**RE: Environmental Assessment EA0809-002, Prairie Creek Mine
Winter Road Alignment**

Prairie Creek Mine Access Road Proposed Alignment Changes

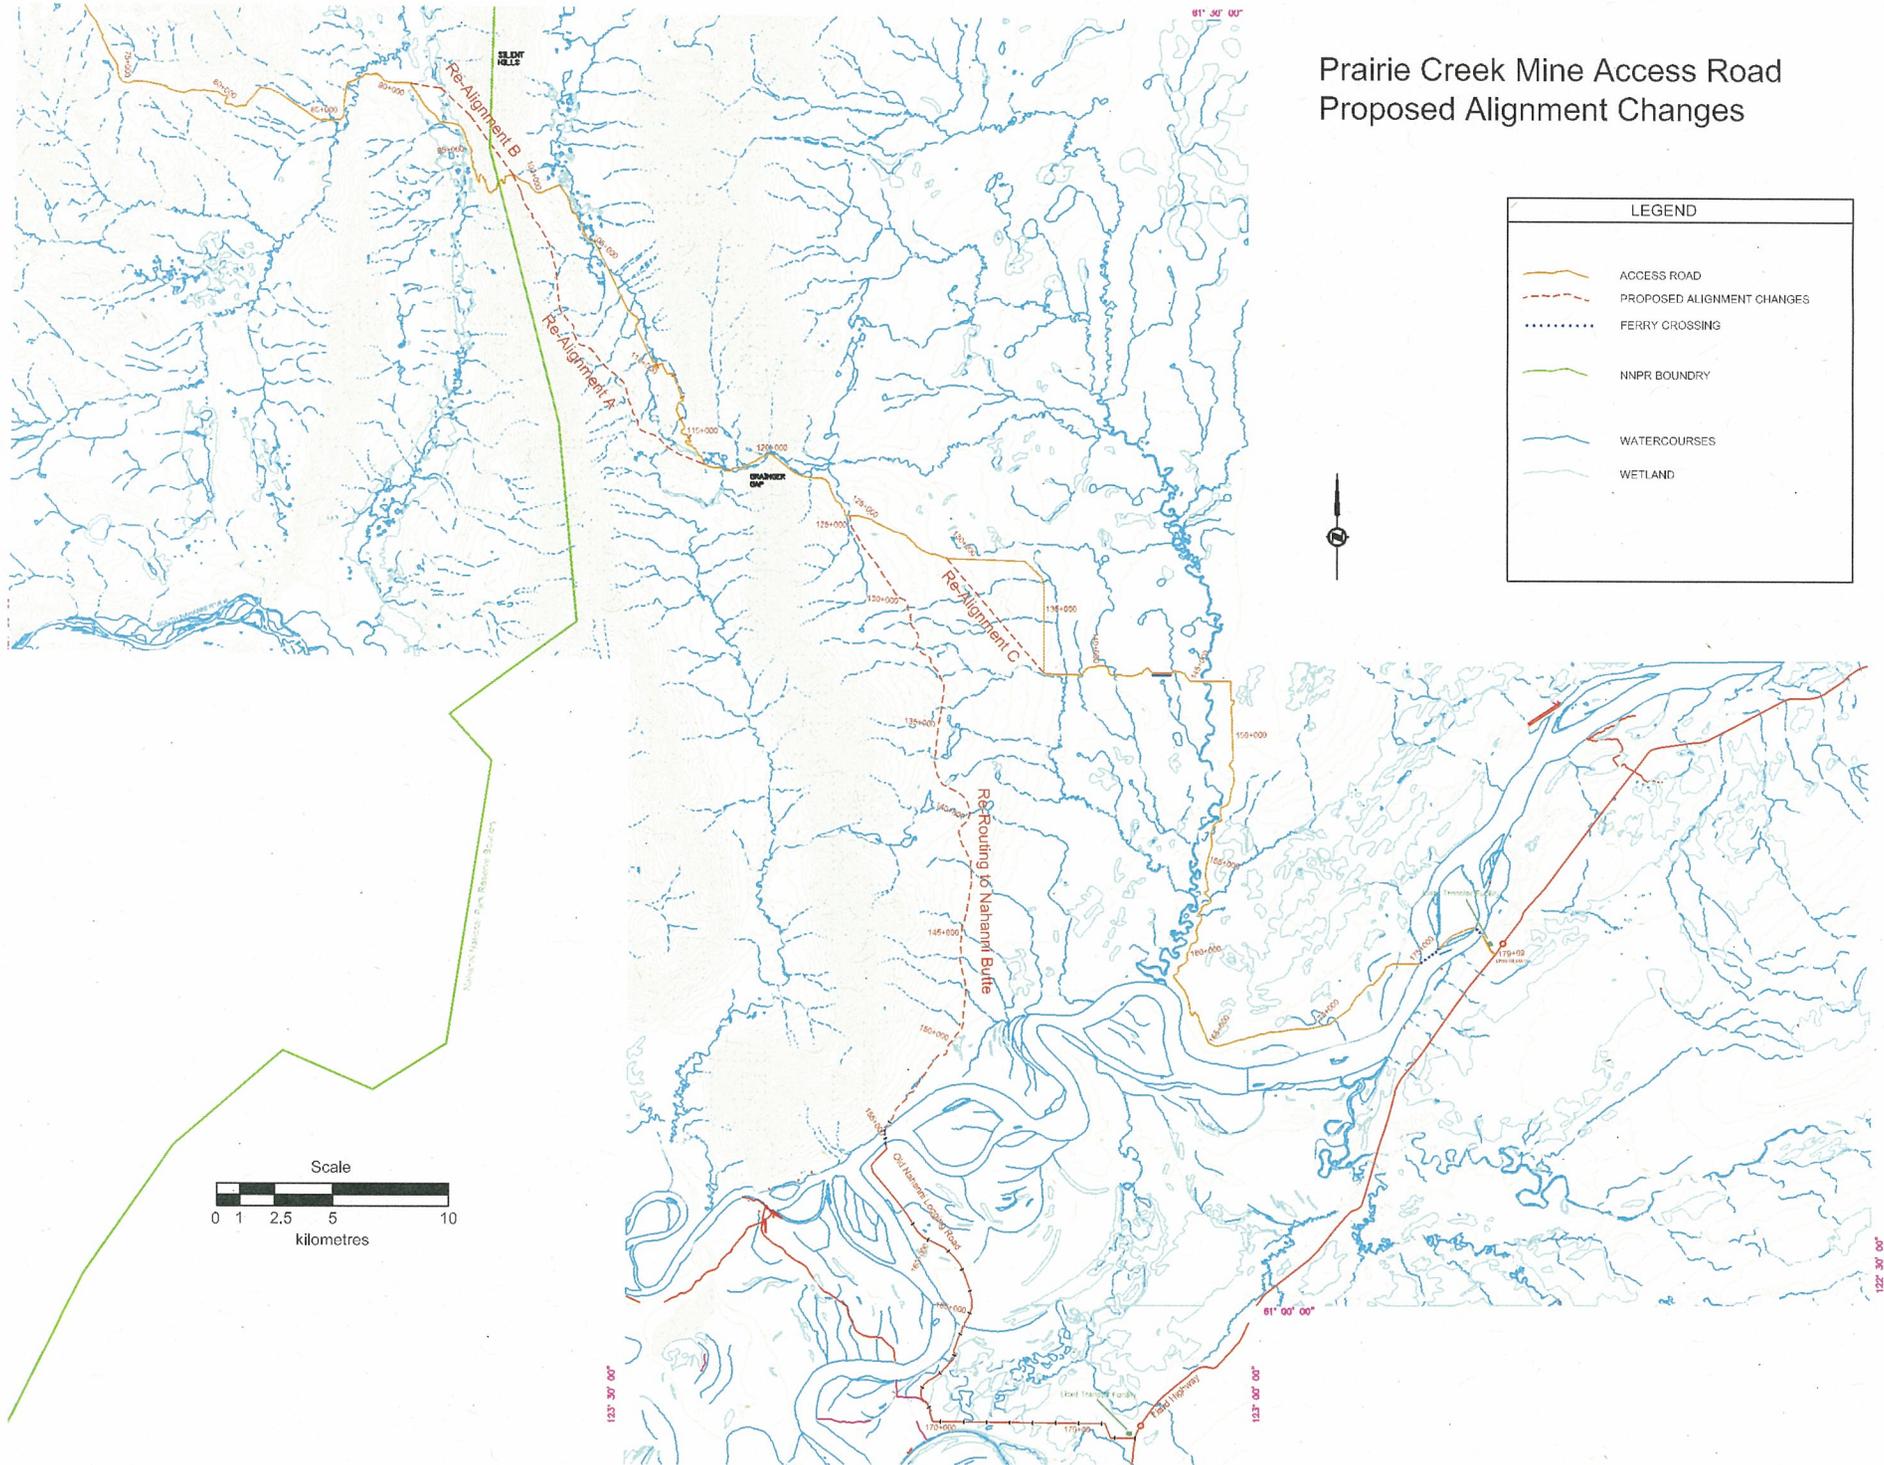
Please refer to the attached figure which shows (marked in red dashes) the four changes to the road alignment being considered at present. The first two were requested by the NBDB and are

The re-routed alignment would turn south from the Grainger Gap at road kilometre marker Km 120 and run along the lower slopes of the First Range towards Nahanni Butte. The proposed location of the ice bridge across the Liard River is in a location recommended by the NBDB. East of the ice bridge, the alignment would follow an existing logging road until joining with the NBDB's existing all season access road to the Liard Highway.

CZN has also previously flown such a route, as shown on the figure departing the existing alignment at Km 96 and re-joining at Km 112, and consider it to be feasible to build consistent

CZN's proposed re-alignment from Km 89 to Km 96 crosses the Fishtrap drainage further north close to the headwaters (the watershed), and then immediately starts up the slope towards the pass. The benefits of this alignment are that the length of road in or near wetlands is minimized, consistent with the NBDB request east of Silent Hills, and starting up the slope further to the north allows a more gradual ascent to the pass and removal of the sharp turns. Thus, environmental protection and safety, both of which promote environmental protection, would be enhanced.

The existing alignment takes a circuitous route from the Granger Gap to the Grainger Camp. It appears again that existing cut lines were used in the original construction. The timber along this portion of the route has largely re-grown. The proposed re-alignment from Km 123 to Km 131 would be shorter, and therefore would mean less logging. Ground conditions and other considerations appear to be the same. This re-alignment would not be necessary if the re-routing towards Nahanni Butte discussed first above is adopted.
